Addendum #7

CONSIDER IN YOUR RESPONSE/BID THE FOLLOWING ITEMS OF ADDITION, DELETION OR CLARIFICATION. INDICATE IN THE SPACE PROVIDED ON THE RESPONSE/BID FORM THAT YOU HAVE RECEIVED AND INCLUDED FOR THE REQUIREMENTS OF THIS ADDENDUM. SICKKIDS MAY, IN ITS SOLE DISCRETION ANSWER SIMILAR QUESTIONS FROM VARIOUS RESPONDENTS ONLY ONCE.

RE: QUESTIONS AND ANSWERS, SPECIFICATIONS, DRAWINGS AND DOCUMENTS

1 LEVEL 2 PART PLAN - PLUMBING - DEMOLITION
SCALE: 1:50

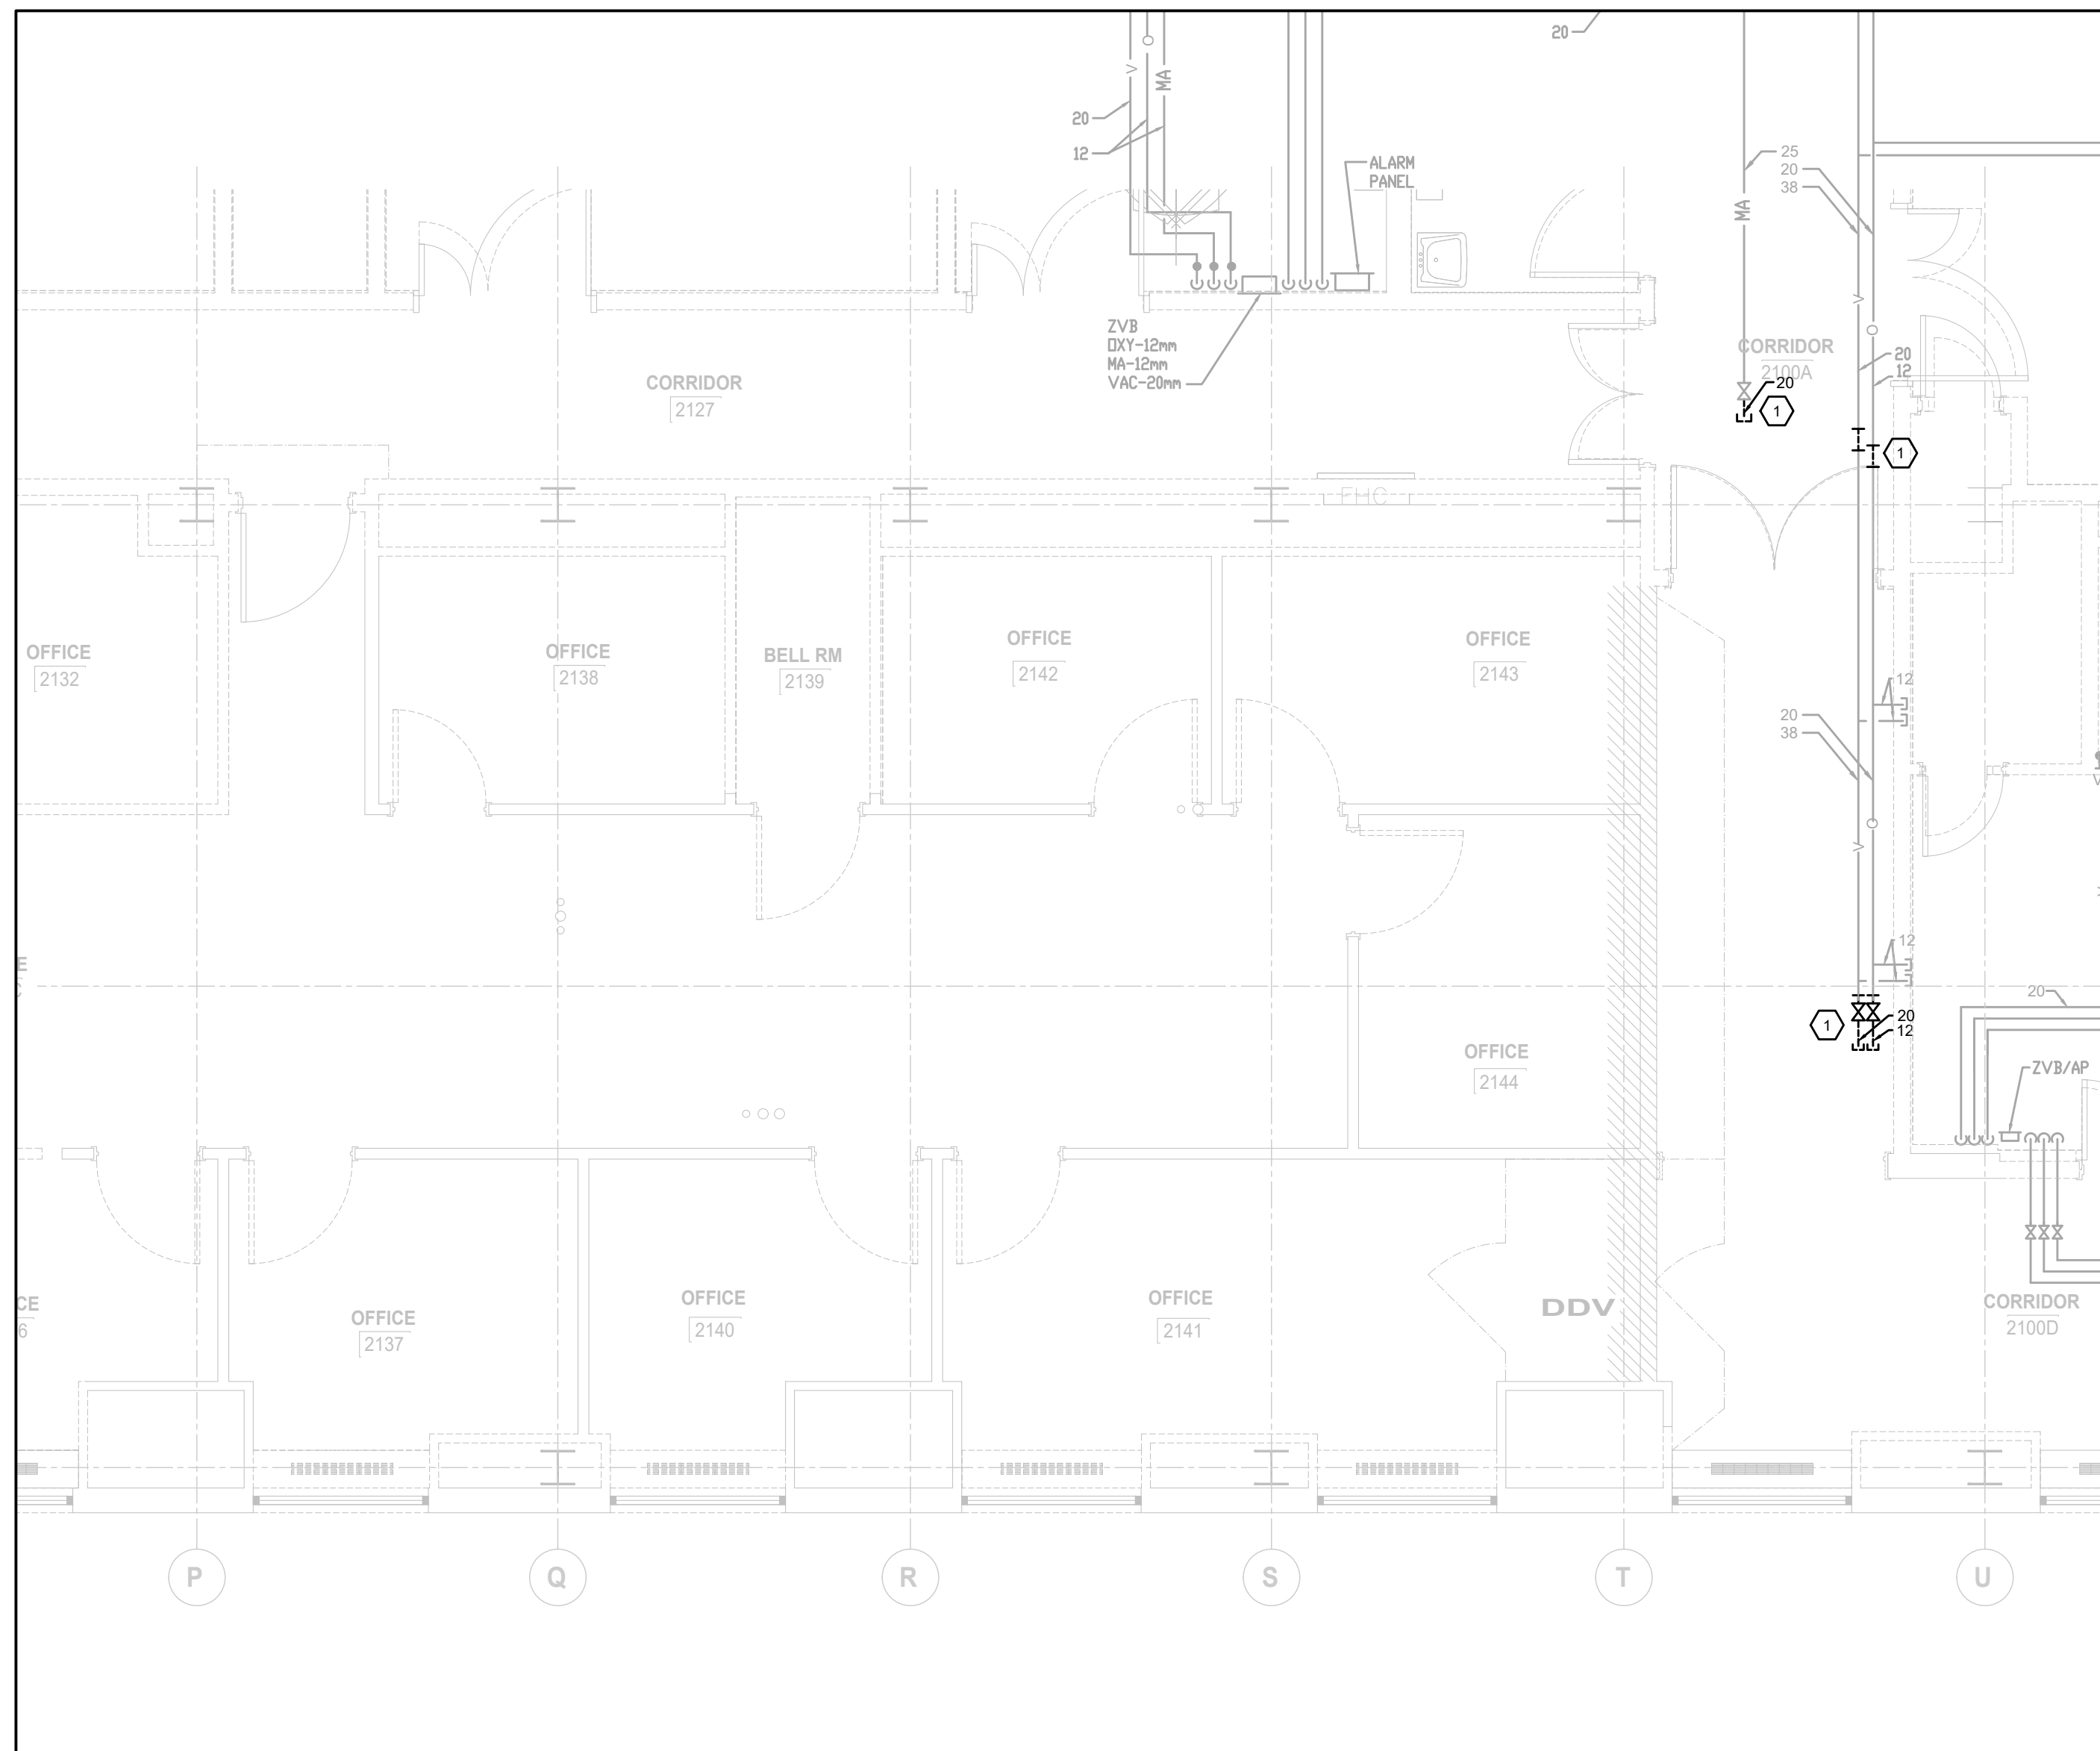
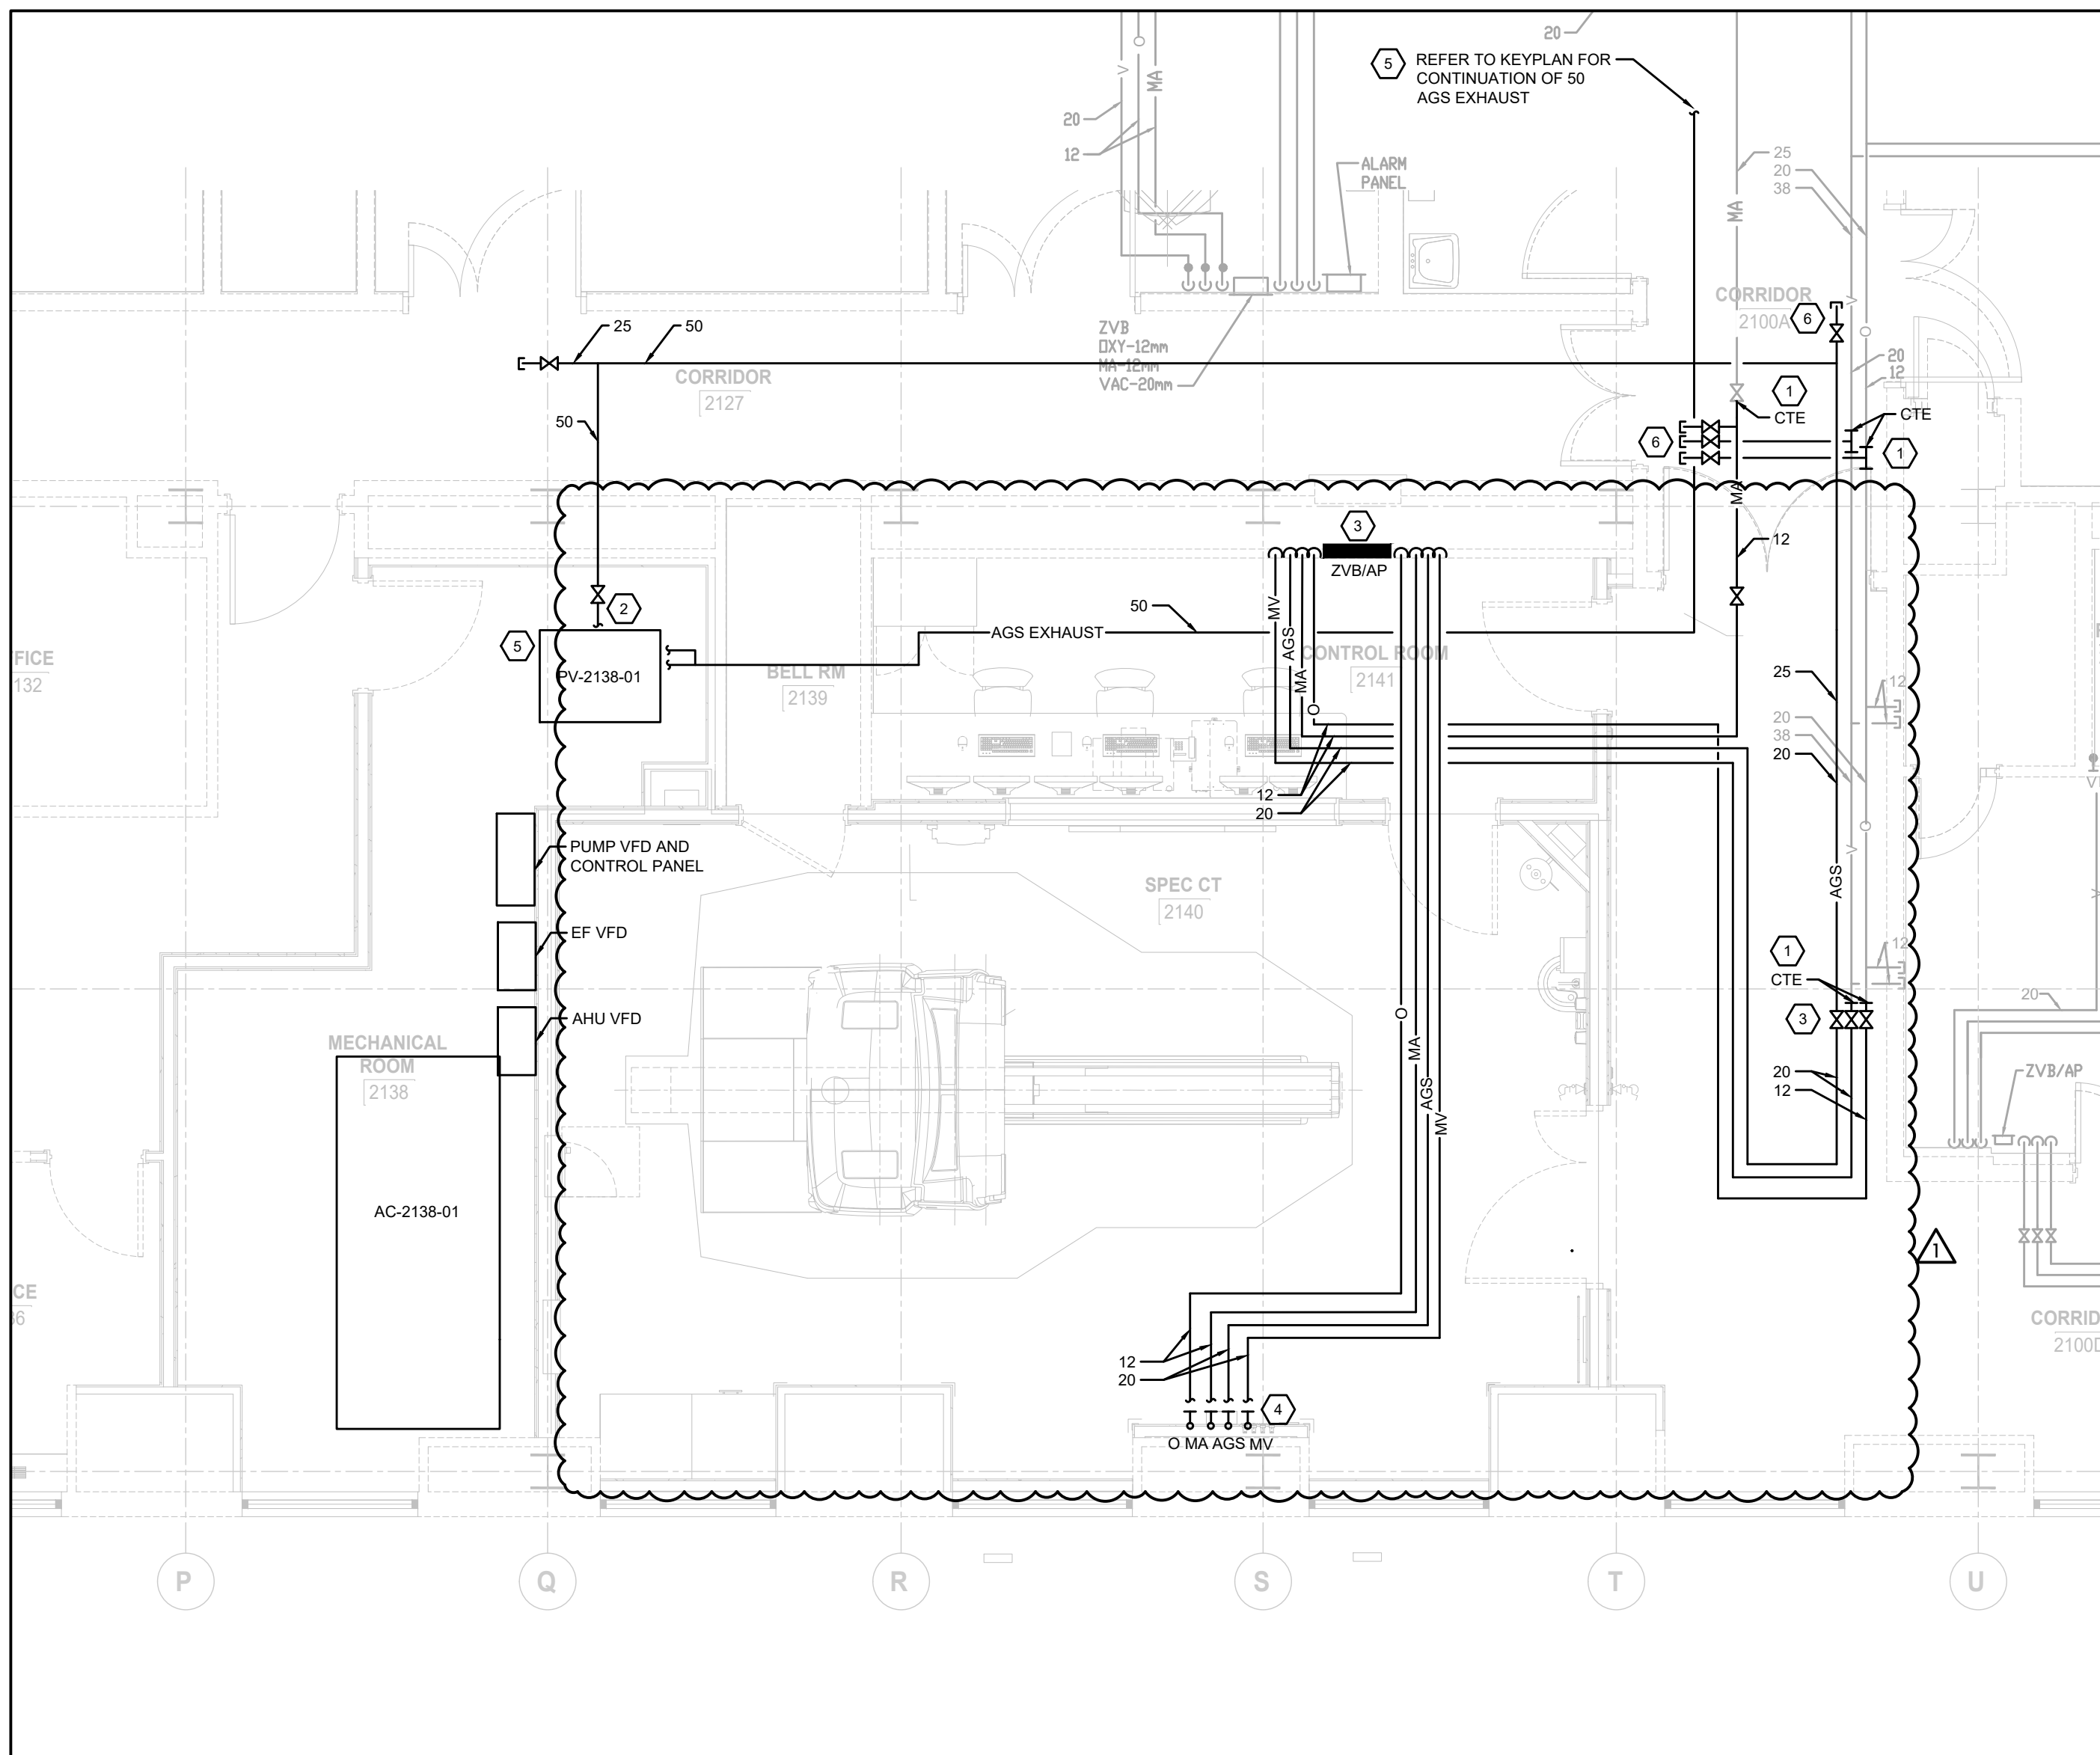
- Revisions to domestic water pipe size.
3. **Drawing MP 02 EW 01 – LEVEL 2 PART PLANS – PLUMBING – DEMOLITION AND NEW WORK.**
 - Revisions to drawing sheet keynotes.

- Revisions to new work plans.
4. **Drawing MG 02 EW 01 – LEVEL 2 PART PLANS – MEDICAL GAS – DEMOLITION AND NEW WORK.**
 - Revisions to ZVB/AP location and associated piping.

0. MV 01 EW 01

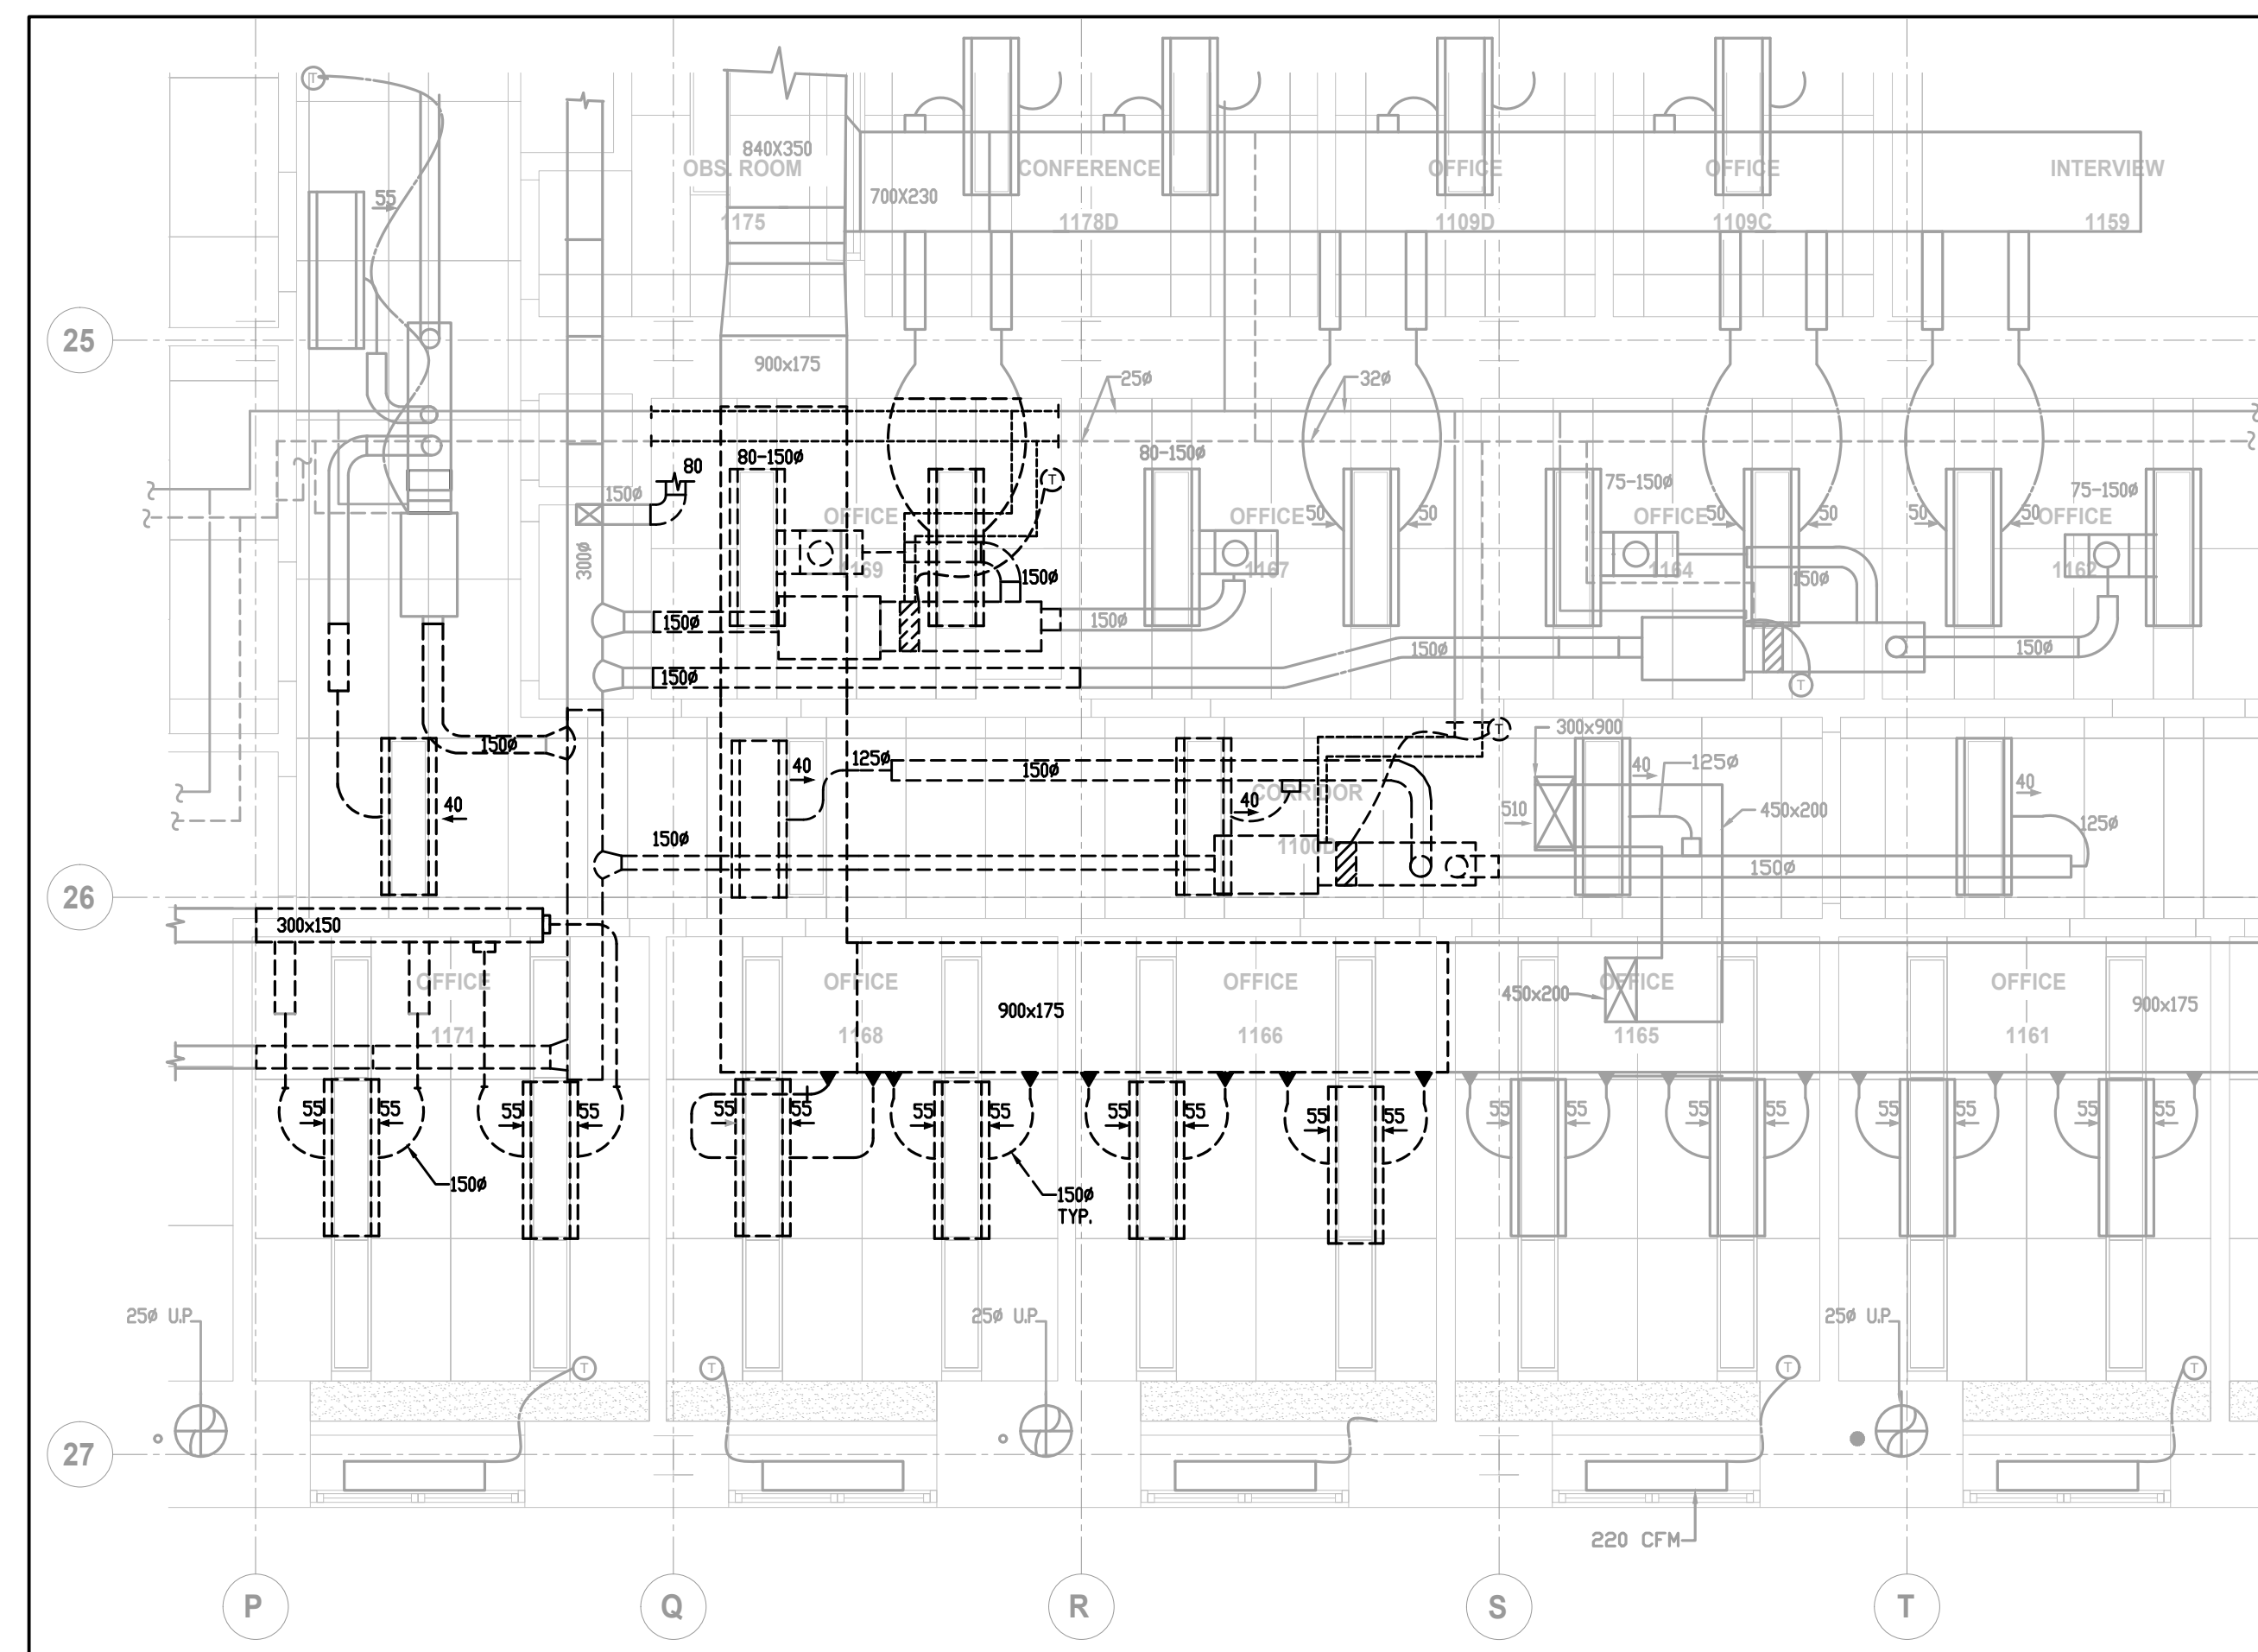
- New sheet to capture HVAC work on Level 1.
7. **Drawing MV 02 EW 01 – LEVEL 2 PART PLANS – HVAC – DEMOLITION.**
 - Revisions to drawing notes.
8. **Drawing MV 02 EW 02 – LEVEL 2 PART PLANS – HVAC – NEW WORK.**
